## **Generic Design Assessment – New Civil Reactor Build**

**GDA Close-out for the EDF and AREVA UK EPR™ Reactor**

**Spent Fuel Pool Safety Case**

Assessment Report: ONR-GDA-AR-12-012

**Figure 1.** Schematic view of the FPCS Main Cooling Train 1 – Single Pump in Service

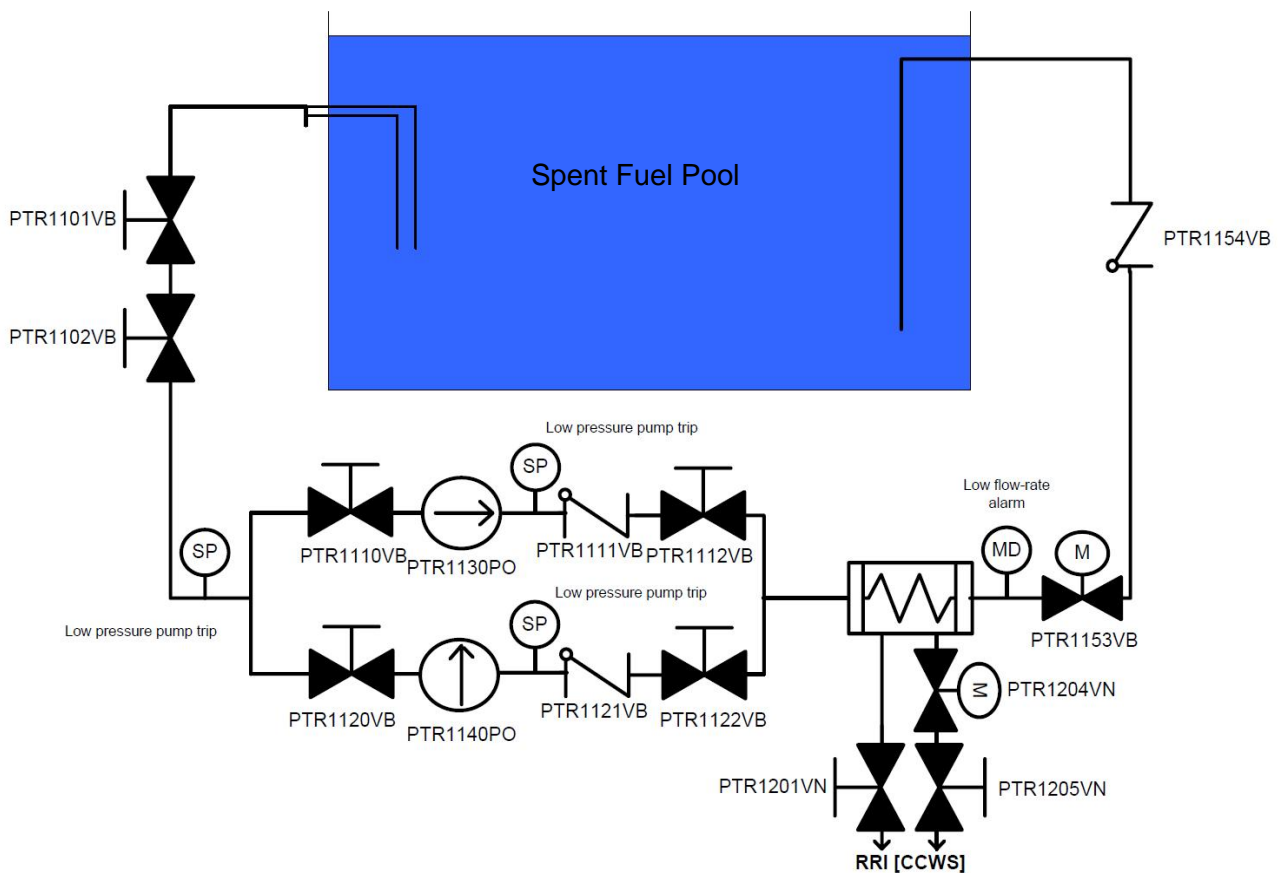
- 81 Figure 1 presents the schematic diagram of one of the cooling trains and its main components that are provided to remove heat loading from the SFP. I note the absence of a zero flow line around the pumps in the cooling trains, which is normally included as part of the system to protect the pump and supply piping in situations where the pump is inadvertently aligned and operated with a valve downstream being shut.

- 82 In response to a query in TQ-EPR-1616 (Ref. 13) relating to the absence of a zero flow line, EDF and AREVA have stated that the valves around the pumps are normally open (except during maintenance periods) to allow the start-up of a pump or a cooling train from the Main Control Room (MCR) without the need for any local action. The TQ response also indicates that in the case of misalignment an alarm on low flow in the discharge line is initiated into the control room. It is also claimed that, should the problem remain, and pressure sensors detect low flow on the common suction side and/or discharge of the pump, it will be automatically tripped. EDF and AREVA have therefore concluded that the mechanical configuration and the design of the C&I justifies the absence a of zero flow line around the pumps within the main SFP cooling trains.

- 83 I have considered the response and judge that whilst the presence of the instrumentation to monitor the flow in the discharge line informing the operator of fault conditions within the coolant line offer some protection to the pump and adjacent piping, it is unlikely to be an adequate justification to protect the pumps in fault conditions or misalignments. Specifically, in accordance with SAP FP.3 and EKP.1, I consider that the current proposals which rely on the C&I do not demonstrate a robust protection of the system for

84 From the information provided in response to TQ-EPR-1616 (Ref. 13) and supporting information, I have judged that there is a lack of clarity in strategy for tripping the pump in adverse conditions in order to minimise risk to plant operation. I have therefore raised an Assessment Finding requesting the licensee to perform an examination of the proposed option to further explore the advantages of such a concept during the detailed design phase as part of the site specific activities. This justification is expected to provide a justification of the SFP cooling system configuration and the reliance on the C&I to protect the system. The justification should also demonstrate sufficient level of integrity of the proposed claims on the C&I to maintain and protect the operation of the cooling system.

***AF-UKEPR-FS-77:** The Licensee shall provide a justification of the proposed system configuration to demonstrate that reliance on the C&I to protect the FPCS pumps and adjacent piping is most appropriate for the overall system availability and operation.*
